27 July 2026

Minor Change to Development Approval Over Land at 450 Queen Street, Brisbane City (Council Ref: A005905778)

3 Proposed Changes

Figure 2 Ground Floor and Lobby Reception

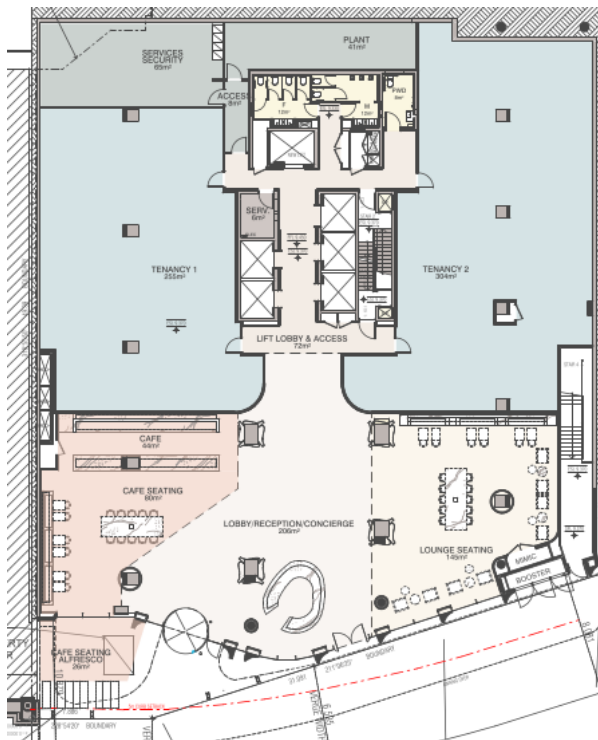
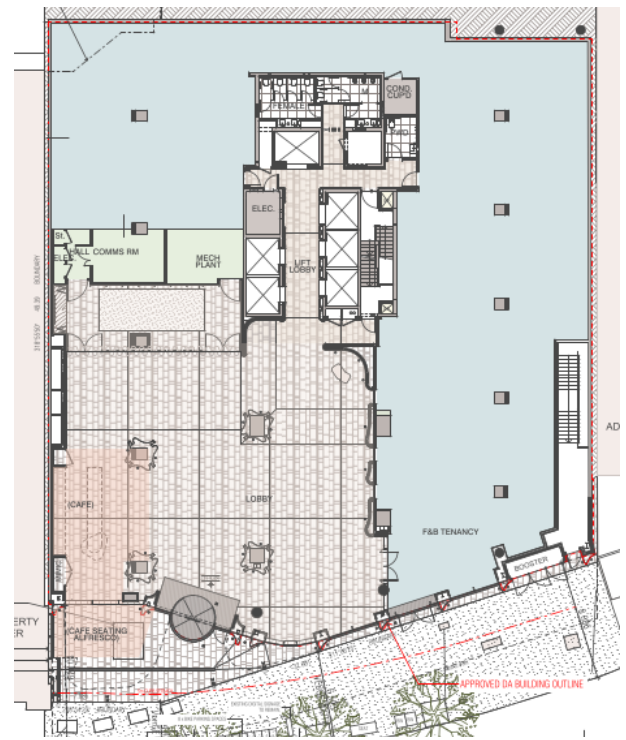
- establishment of a larger food and drink outlet tenancy at ground level with a GFA of 669m²;
- relocation of the secondary tenancy entry to food and drink outlet;
- rationalisation of the café tenancy and alfresco seating arrangement with a GFA of 81m²;
- refinements to the amenities within the ground floor public lobby.

- removal of the lounge seating area.
- relocation of plant room, mech and comms equipment.
- relocation of visitor bicycle parking spaces in front of café and to public verge (discussed in further detail in **Section 3.3**).
- enclosure of gas meter with screening along western boundary (discussed in further detail in **Section 3.4**).

The revised substantially maintains the approved building envelope while delivering a more active and commercially viable ground plane outcome. The expanded food and drink tenancy will increase pedestrian activity and improve passive surveillance and activation along the street frontage, consistent with the intent of the City Centre Neighbourhood Plan and Centre Activities and Mixed Use Code.

Figure 3 – Approved Streetscape Works Plan

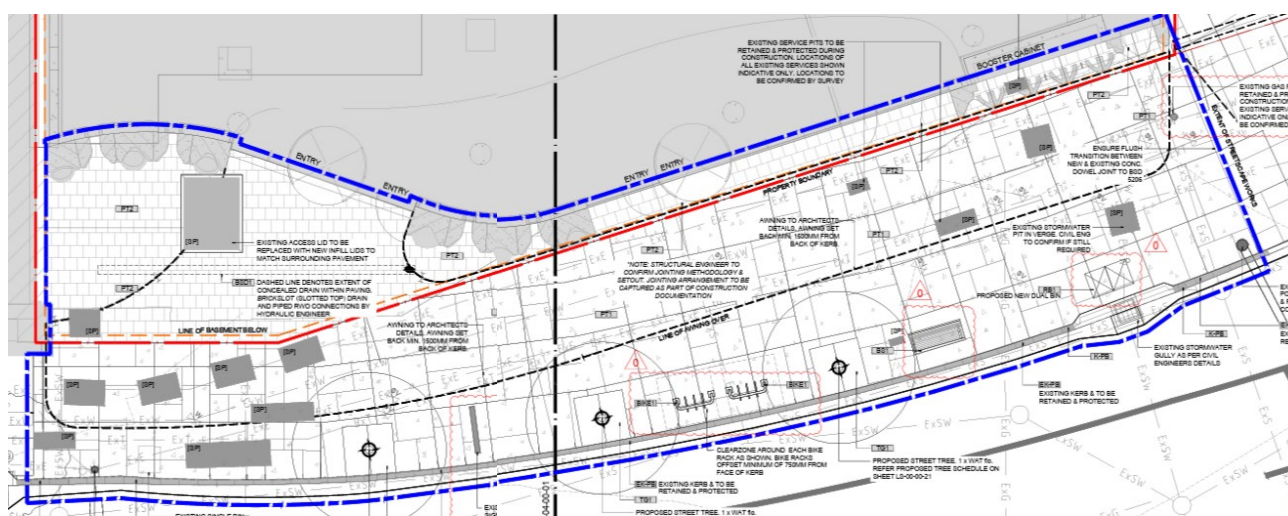
The proposed relocation of visitor bicycle parking reflects the approved Landscape Works in Streetscape outcome endorsed by Council (Ref: A006739251), which includes provision of eight publicly accessible bicycle parking spaces within the verge adjoining the site, shown in **Figure 3** below.

- the bicycle spaces remain directly adjacent to the site and in close proximity to the principal building entry;
- the spaces are clearly visible, publicly accessible and convenient for visitors;
- the spaces avoid obstructing necessary services and equipment located within the site such as the substation and gas meter;
- the verge location does not impede pedestrian movement or access to the building;
- the arrangement integrates with the approved streetscape design and broader active transport network; and
- the spaces will function equivalently to visitor bicycle spaces located within the site boundary.

Figure 4 Gas Meter Plan

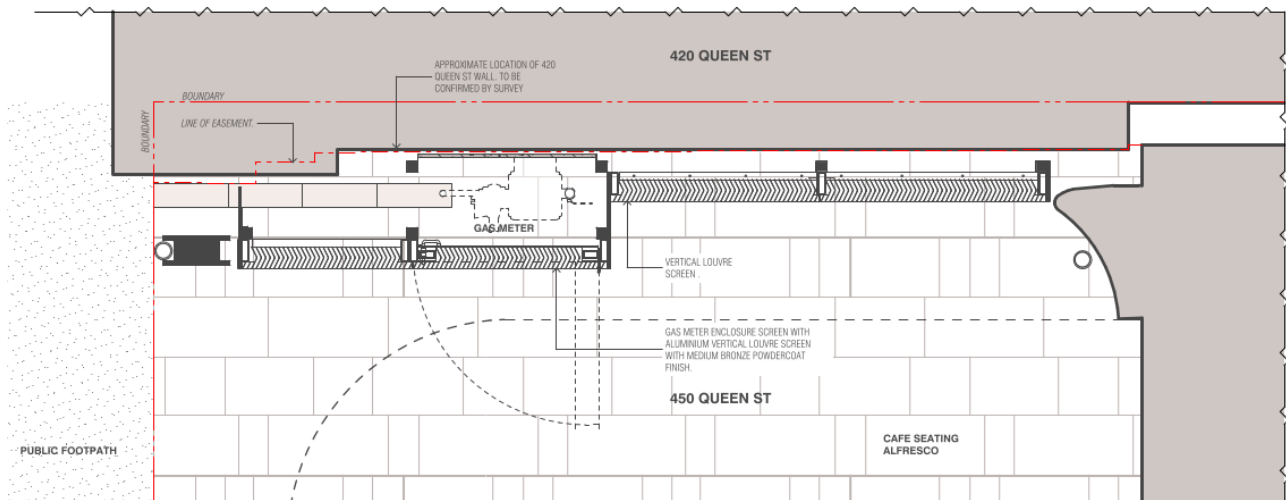
A new architectural screen is proposed along the western Queen Street boundary to enclose the gas meter infrastructure associated with the development.

The enclosure has been carefully designed as a lightweight and recessive element comprising vertical aluminium louvres with a medium bronze powder-coated finish. The screen improves the visual presentation of the ground floor frontage and integrates the servicing infrastructure into the overall architectural language of the development.

Figure 4 illustrates the proposed screen in plan form and **Figure 5** provides a 3D representation of the proposed outcome.

Figure 6 Podium Level 1

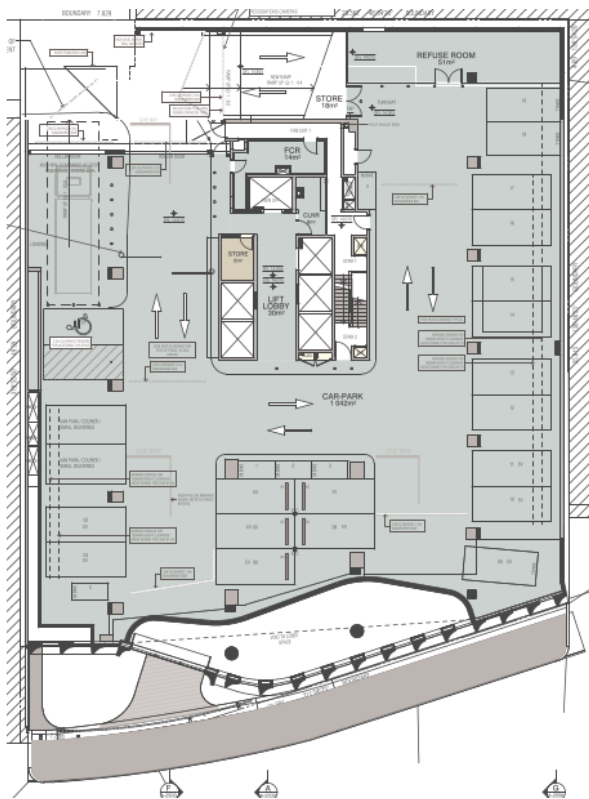
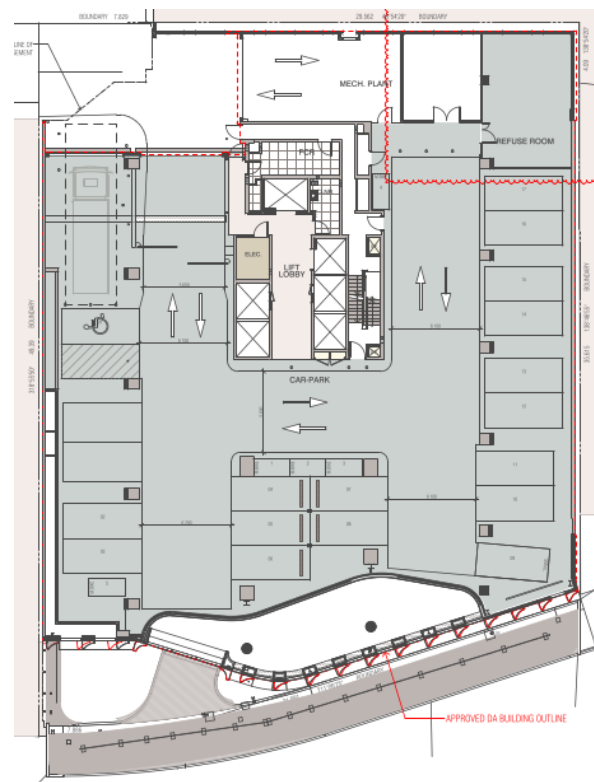
Minor refinements are proposed to the Level 1 podium layout to accommodate the expanded refuse area associated with the revised ground floor tenancy configuration.

- extension of the waste storage area;
- provision of an additional storage room; and
- removal of two standard car parking spaces.

Figure 7 Podium Landscaping

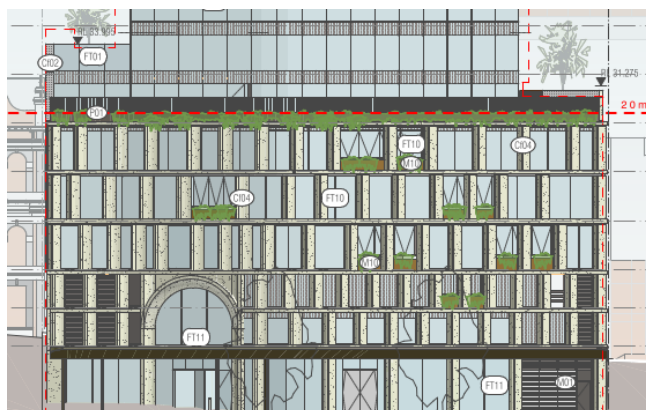
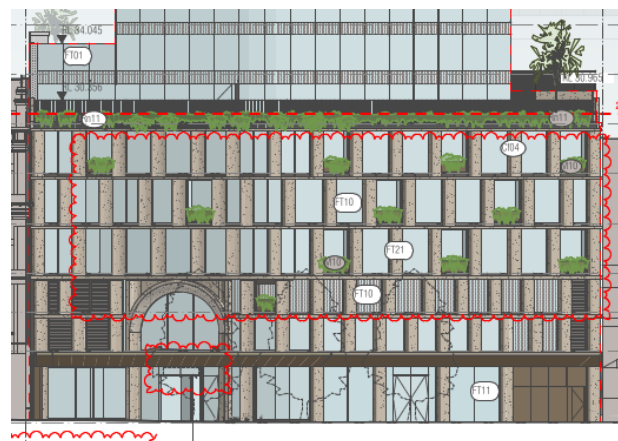
- minor adjustments to façade planter locations across Levels 1 to 5; and
- refinement of planter configurations within terrace areas on Levels 6, 7 and 23.

Importantly, the amendments do not reduce the overall landscape provision. The revised scheme provides 229.5m² of landscaping compared to 228m² previously approved, as outlined in the Landscape Technical Memo provided as **Attachment H**.

Figure 8 – Changes to Terrace Landscaping

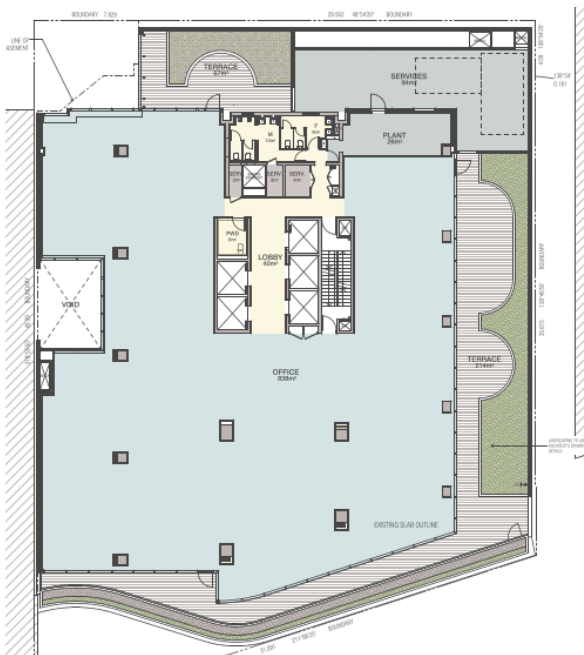
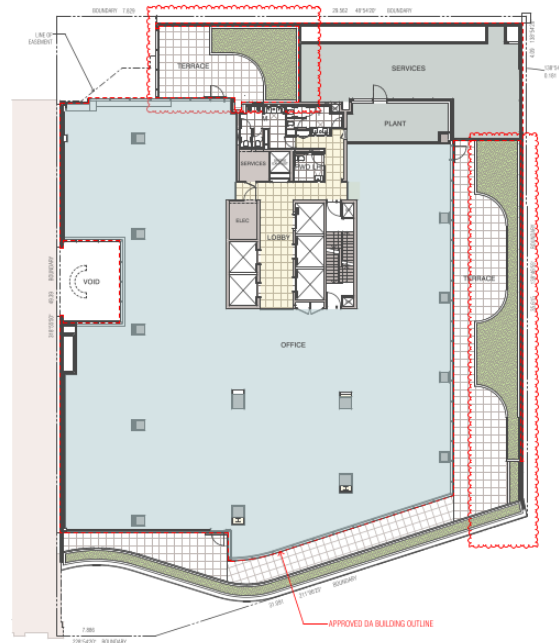
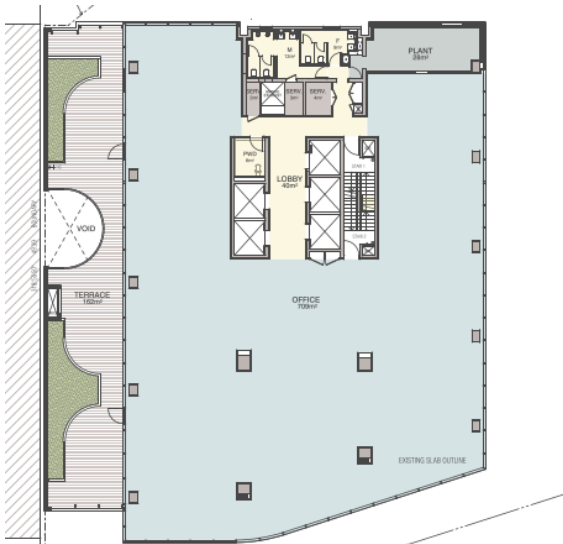
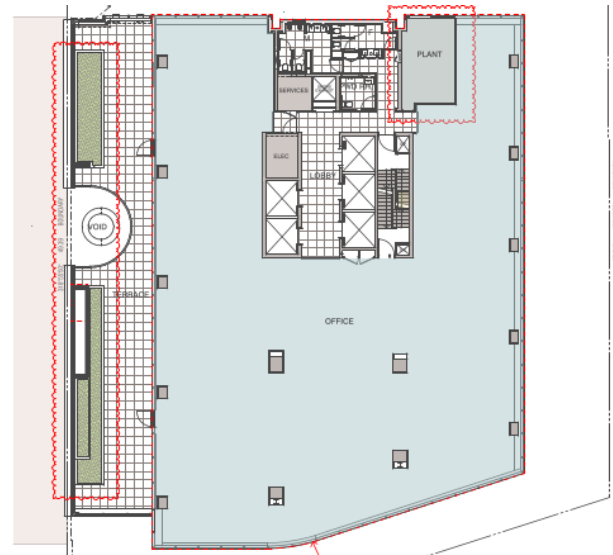
The terrace landscape refinements similarly improve usability and operational performance while maintaining the overall landscape outcomes previously endorsed by Council.

Figure 9 – Rooftop Changes

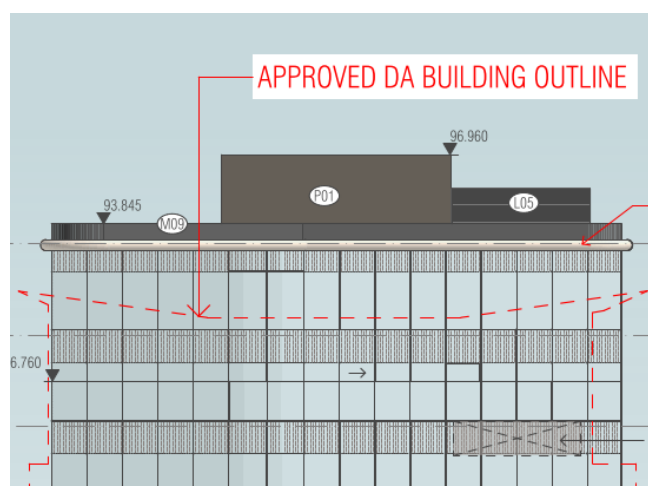
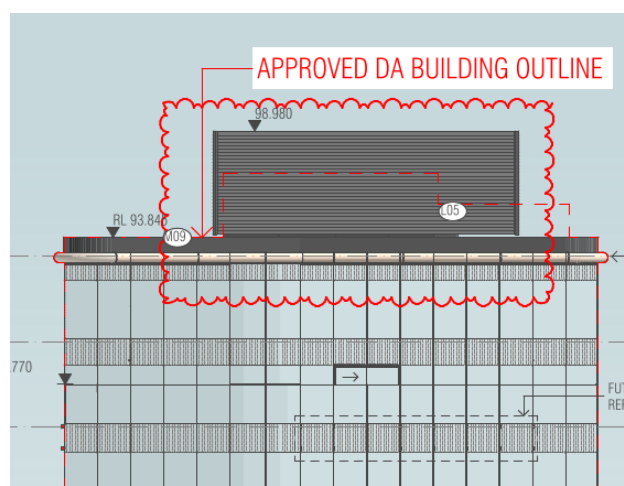
The rooftop design has been refined to incorporate additional architectural screening to fully conceal smoke lobby exhaust ducting and associated rooftop plant infrastructure. As a result, the maximum height of the rooftop screening increases from RL96.960 to RL98.980, shown below in **Figure 9**.

The proposed amendment is minor in nature and does not materially alter the scale or visual presentation of the approved tower. The additional height is limited to lightweight screening elements associated with building services and does not increase the occupied floor area, tower footprint or building storeys.
